Reference: 1053, 1075, and 1145 March Road – CU Developments Inc.
Geometric Road Design Drawing
Our File No.: 116132

A Geometric Road Design (GRD) letter, dated April 2021, and Comment Response letter, dated May 2022, were submitted to the City as part of the detailed subdivision engineering application. Following the latest engineering submission, modifications to the roadway geometry have resulted in a need for revisions to the GRD Drawings. This letter has been prepared to summarize the proposed changes to the roadway geometry and includes revised GRD Drawings.

Attachment 1: GRDD Drawings

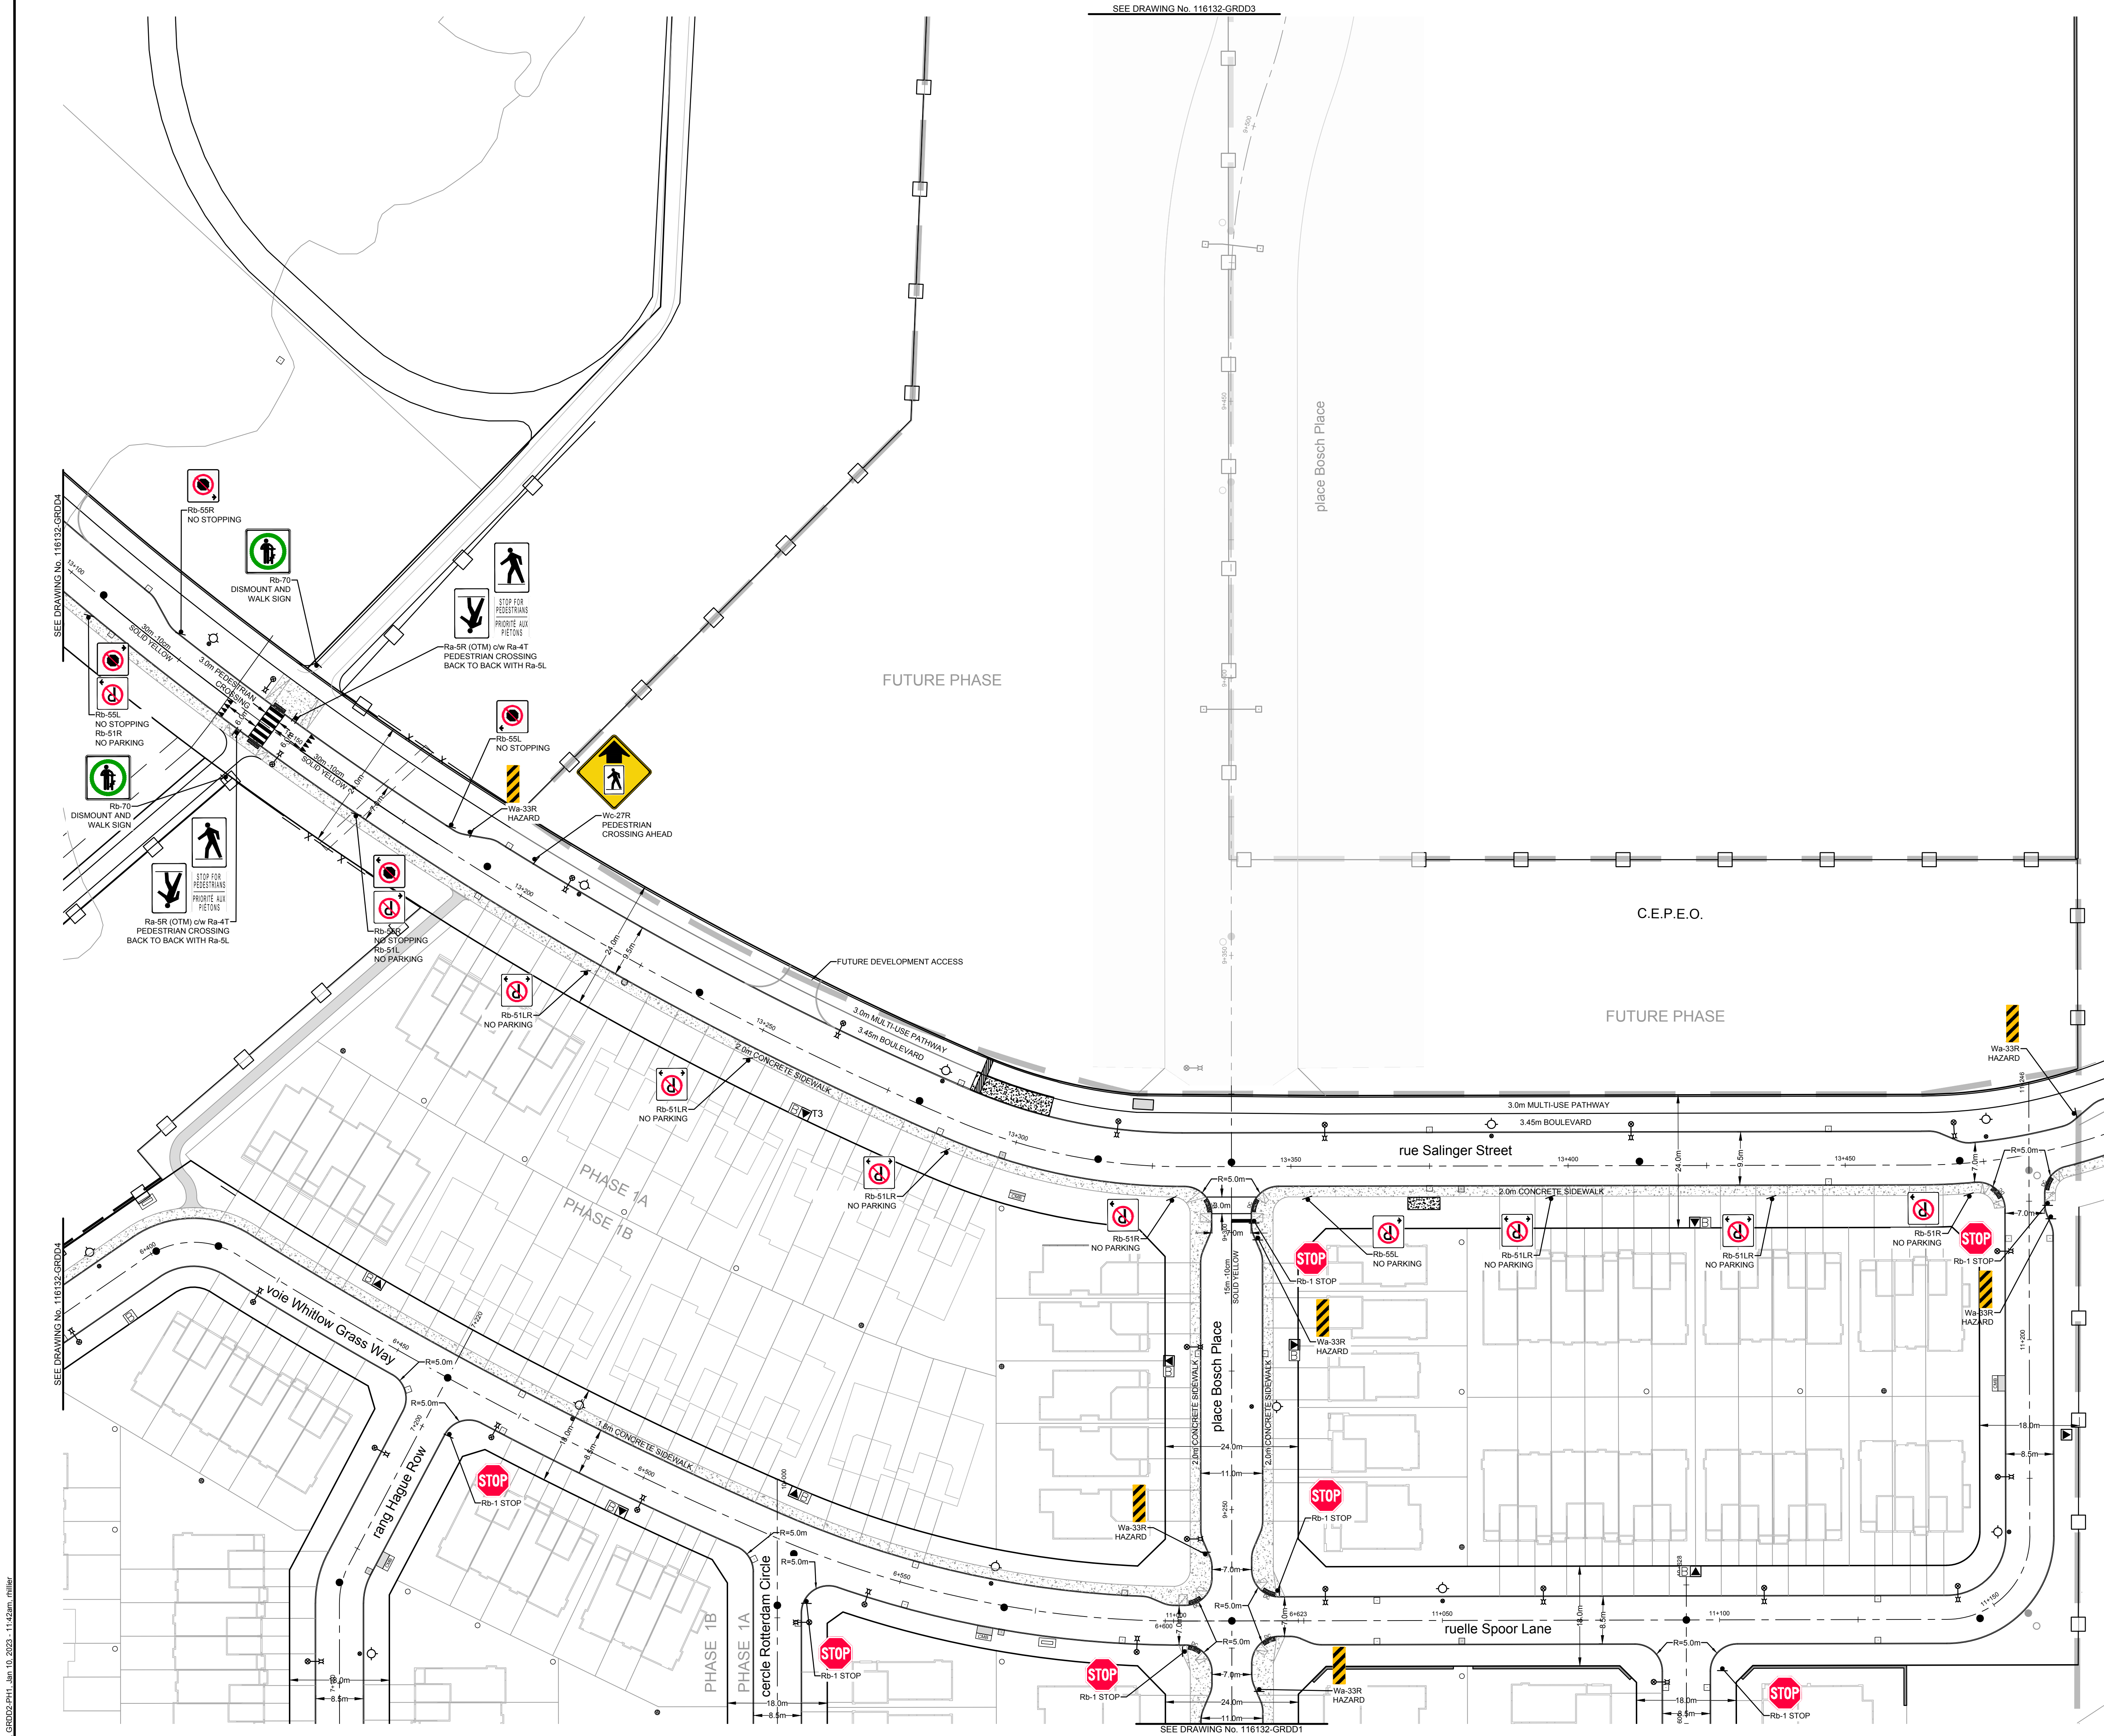
Buckbean Avenue

The sidewalk has been shifted to curbside, while the Multi-Use-Pathway has been shifted to 0.3m from the Right-of-Way line to address comments received by the City's Forestry Department.

Eastern terminus of the on-street parking bay between Salinger Street and March Road has been shifted to west of the future Fire Station driveway.

DRAWING No.
116132-GRDD2

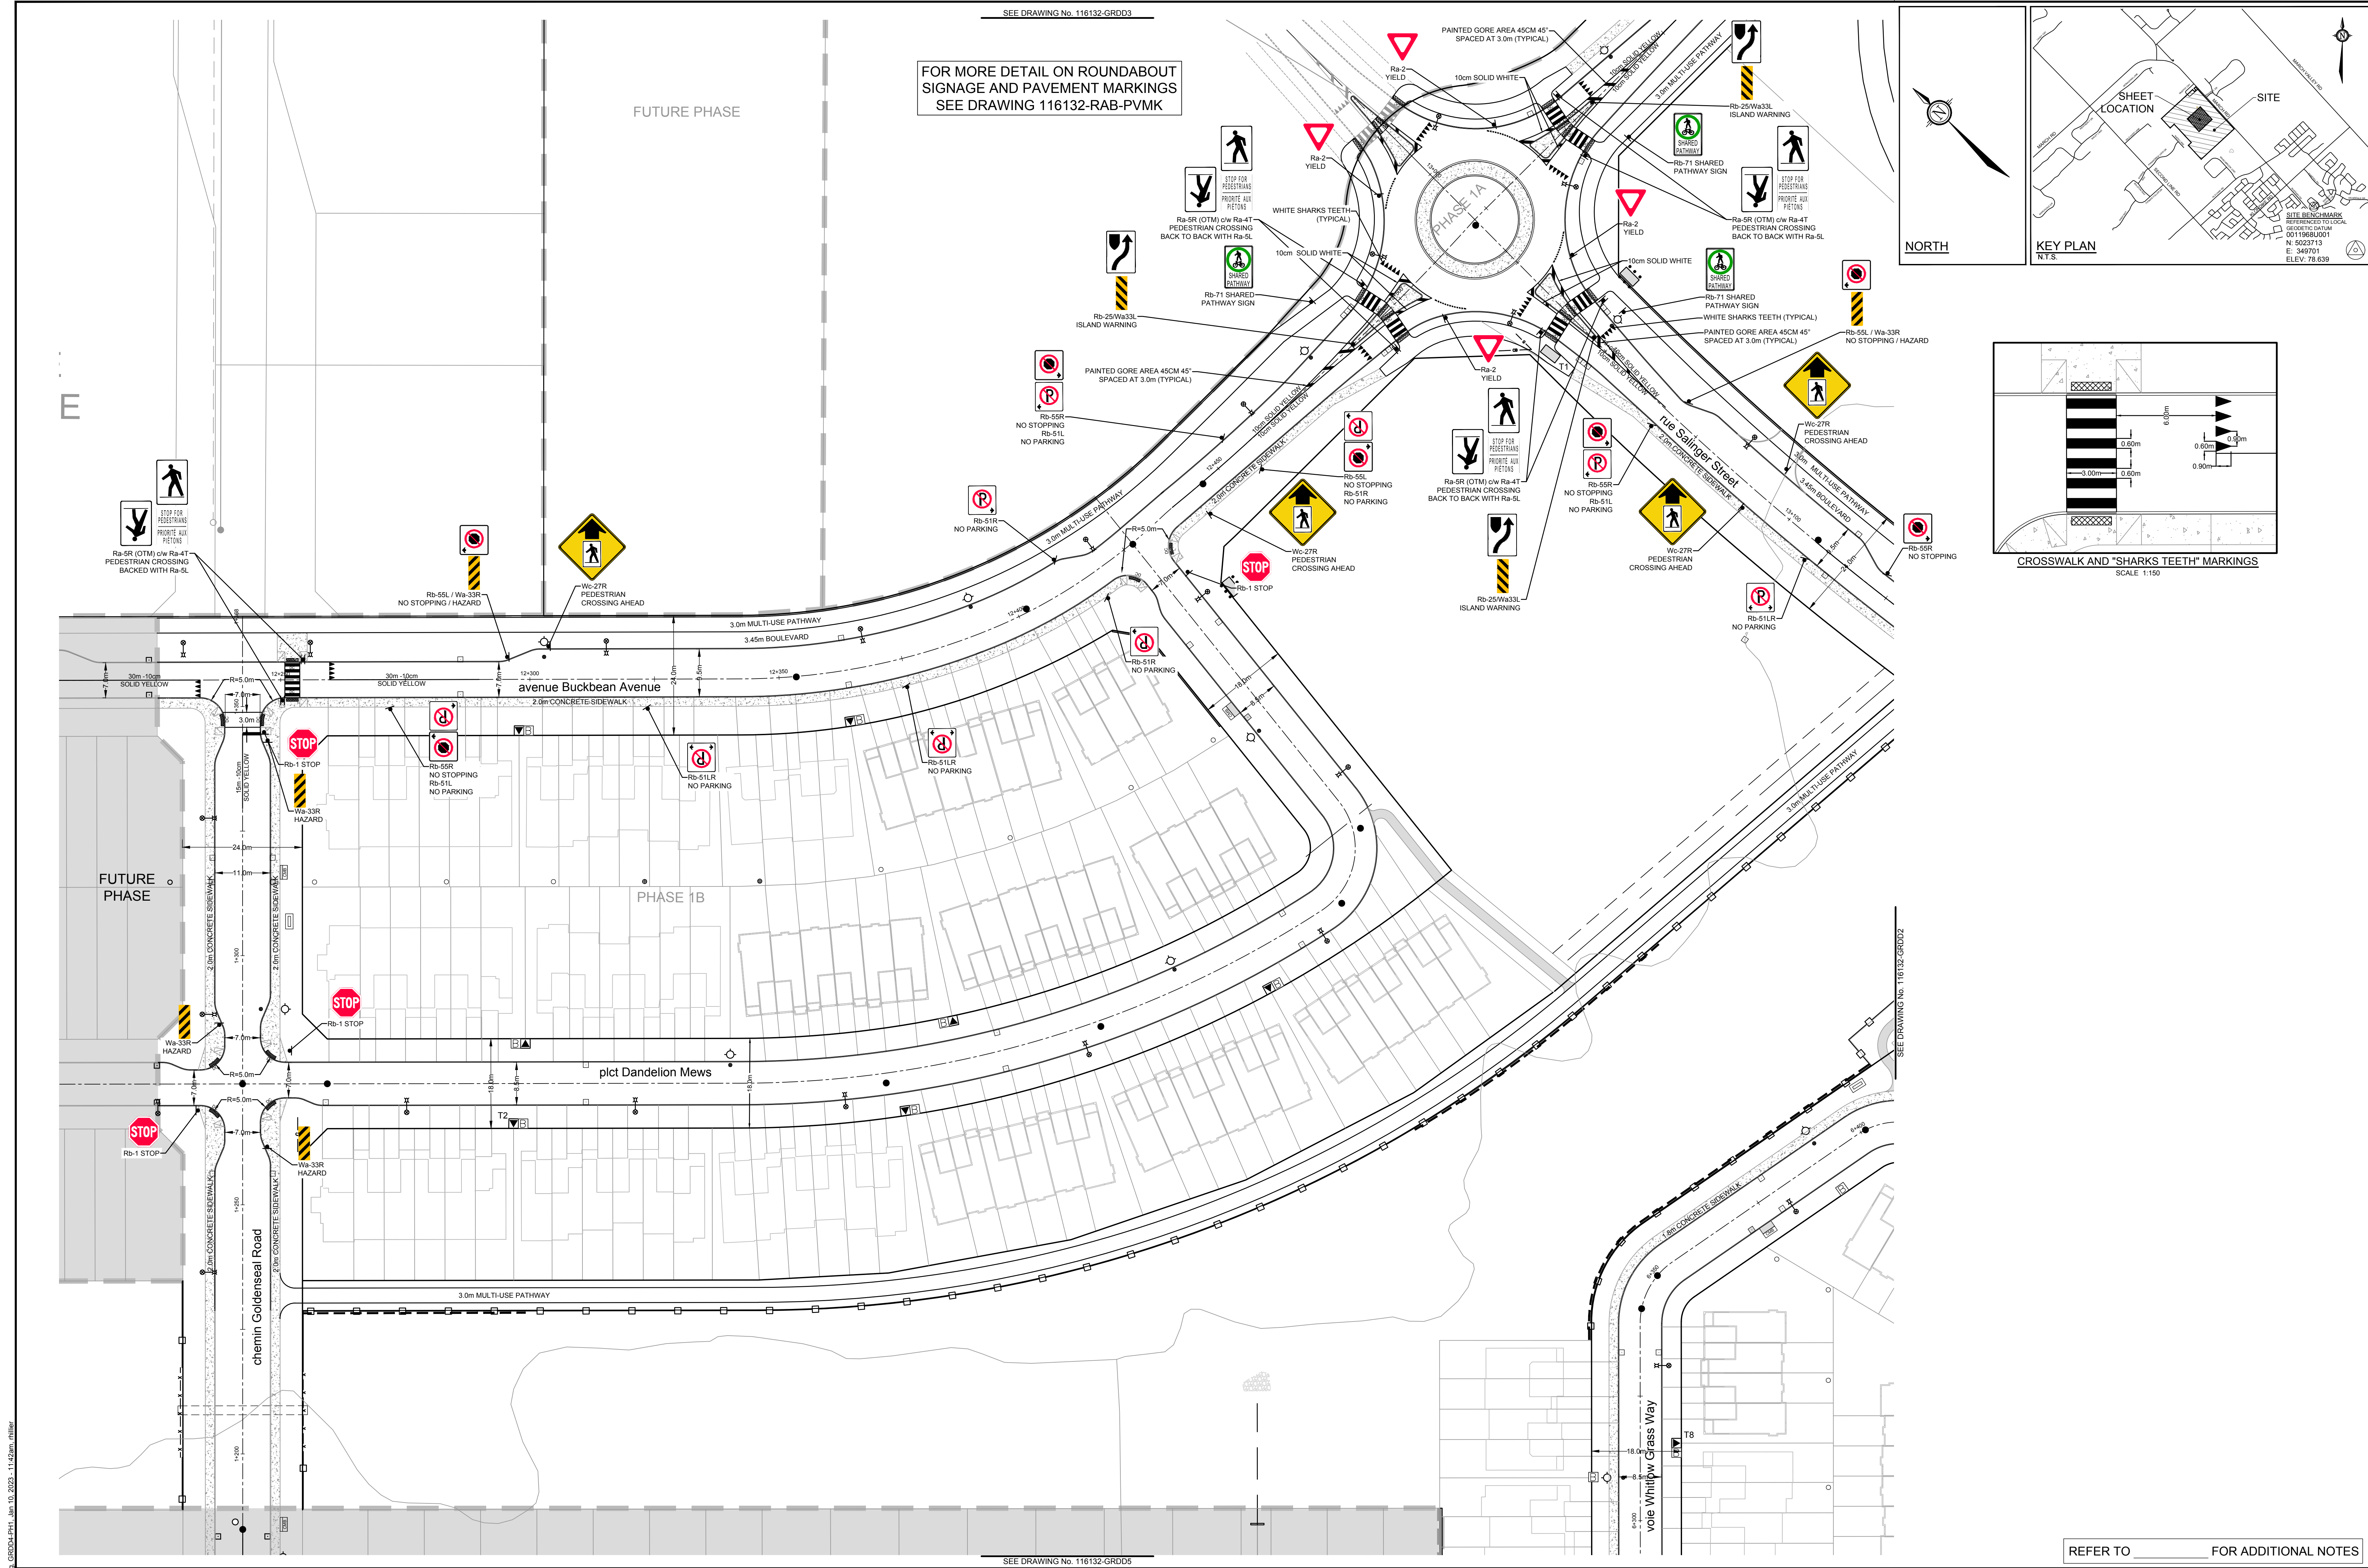
Salinger Street

The sidewalk has been shifted to curbside, while the Multi-Use-Pathway has been shifted to 0.3m from the Right-of-Way line to address comments received by the City's Forestry Department.

A recent preliminary Site Plan has been received for Block 305 within the subdivision. As the proposed access location on the Block 305 preliminary Site Plan conflicts with the previously proposed mid-block narrowing north of Bosch Place, the mid-block narrowing has been removed.

Bus stops have been added near Bosch Place in accordance with discussions with OC Transpo. Signage has been updated in proximity to bus stops.
